CERTIFICATE OF APPROPRIATENESS

RE: Application Number 20-6728; 888 Longfellow Street, Boston – Edison Historic District

HISTORIC DISTRICT COMMISSION PROJECT REVIEW REQUEST

Design Name: Garage Design

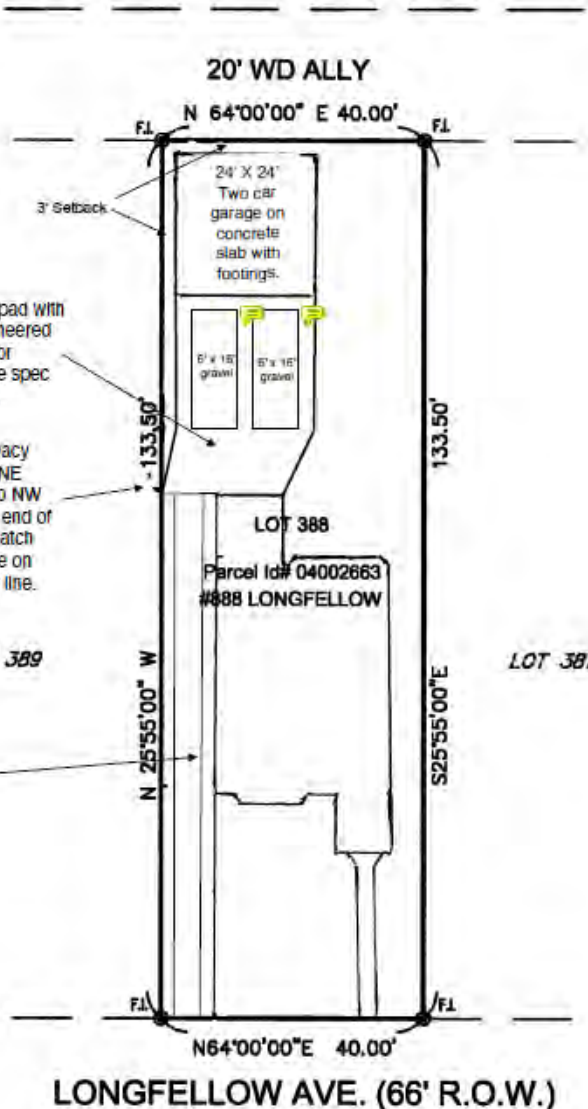
The word document below has facade that illustrates the garage from my garage addendum. This is what an 8/12 pitch roofline looks like.?

My garage proposal does not have a window in the gable.

- Garage footprint will remain the same with the same front door and access door dimensions and placement.
- Garage roof will remain with the same shingles but roofline will be of a standard gable design with an 8/12 pitch (see attachment below)
- Garage roof overhang of 1'
- Garage Wall

- All garage trim, fascia and soffit of smooth cement fiberboard
- Garage cladding will be 12' reveal smooth lap cement board or with a reveal acceptable to the DHC. Painted to match existing home.

This page of the document was received by HDC staff on 6/10/2020 (day of HDC meeting) and was approved by Commission at that meeting.

- The new design option for the garage, with the simpler roofline is to be used. This alternate garage design was presented by the applicant at the June 10, 2020 meeting and was approved by the Commission at that meeting.

-The cladding of the garage is to be of a single material.

-If the applicant chooses to use brick as the material, it must be a true masonry (with mortar) product.

-If the applicant chooses to use Hardie Board material, it must mimic historic wood siding in surface treatment, corner details, depth of profile and dimensions of reveal.

-Paint color selections are to complement the existing house.

-The applicant shall revise the drawing set/construction documents to reflect the updated garage design, material selections, and paint color selections.

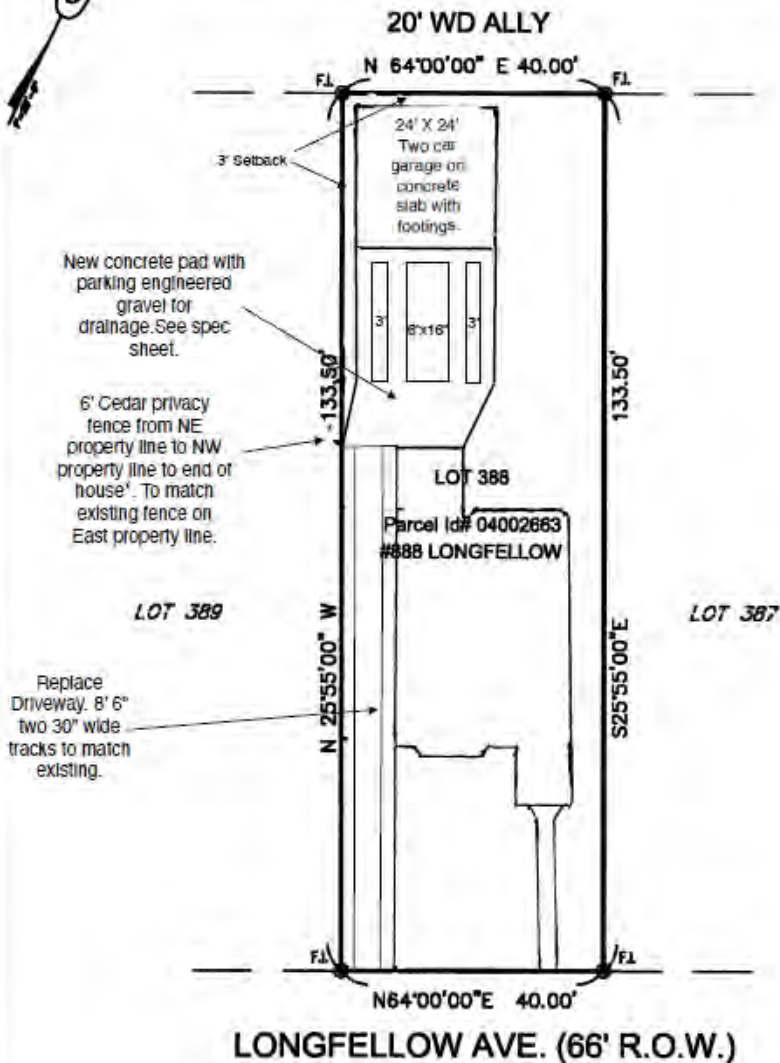
New concrete pad with parking engineered gravel for drainage. See spec sheet.

6' Cedar privacy fence from NE property line to NW property line to end of house. To match existing fence on East property line.

Replace Driveway. 8' 6" two 30" wide tracks to match existing.

REAR ELEVATION

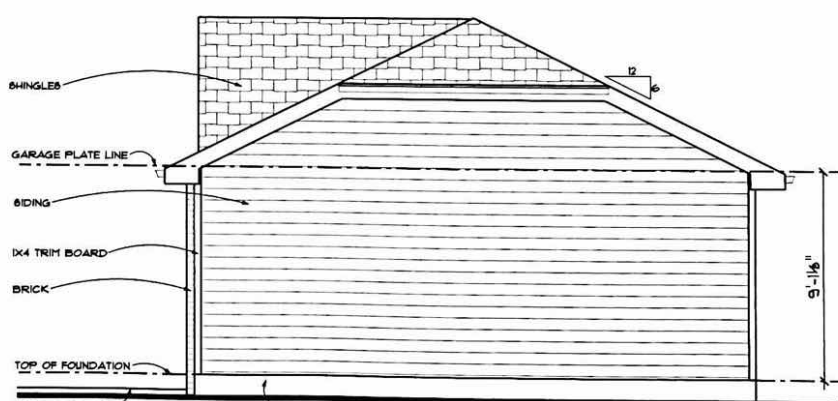
This page of the document was received by HDC staff on as part of the original application submission and was not approved by the Commission. It is included for record-keeping purposes only. See previous pages for the garage design that was approved for the garage.
